RE: Response to Request for Information – 3-5 Help St Chatswood

The purpose of this letter is to address the waste items in the Request For Information for the state significant development application for the proposed development at 3-5 Help St Chatswood.

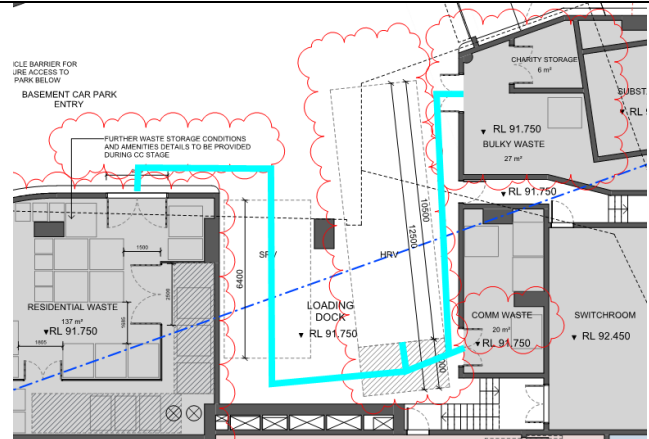
RFI Item raised by Willoughby City Council	Response
WCC-7.1 <i>The attached submission includes comments requesting amendments to ensure waste management meets the requirements of the Waste Management Technical Guide and Development Controls by Northern Sydney Regional Organisation of Councils (NSROC). Conditions are provided at Attachment 2.</i>	It is recommended that the waste management strategy is also assessed under the NSW EPA's <i>Better Practice Guide For Resource Recovery 2019</i>, where the guideline for this document results in better outcomes. It is noted that this document is at the state level and is a more recent publication.
WCC7.2 Collection of residential waste: bins and bulky waste <i>Council services residential waste, including bins and bulky waste using HRV trucks. The approved DA (2023/160), has conditions requiring swept paths to demonstrate that Council's 10.5m long HRV will fit into the site and requiring a 12.5m parking space (10.5m truck and 2m rear clearance). The same requirements and conditions need to apply to the SSDA.</i> <i>While swept paths were supplied (PDC Consultant, Transport Impact Assessment, Lower GF 1 Plan Rev 02, 17.02.2025), onsite collection with a Heavy Rigid Vehicle (HRV) was not clearly stated contrary to the Willoughby DCP 2023 Vehicular Access Requirements (NSROC 2018, p34, Table 11).</i> <i>There are two loading bays shown, an SRV bay and an MRV bay and no bays labelled HRV.</i> <i>There are discrepancies between plans in the length of the truck: o Public domain</i>	- The space designated for the Council Waste Truck has been noted as a HRV bay on the updated Drawing SSDA-1010, Revision D dated August 2025 prepared by Embece - Drawing SSDA-1010, Revision D dated August 2025 prepared by Embece and Public Domain Plan both now show a 10.5m truck - A 2m clearance has been labelled on the architectural plans for the HRV space. Council waste truck will reverse into the loading dock area on arrival and drive straight out on to Help Street on departure. It is anticipated that the SRV parking space would only be used on rare occasions be occupied and therefore the bin carting route could pass through the SRV space in most instances. If the SRV space is occupied, the bins will be wheeled towards the bulky waste area and follow the route towards the rear loading area. The bin moving route is depicted below.
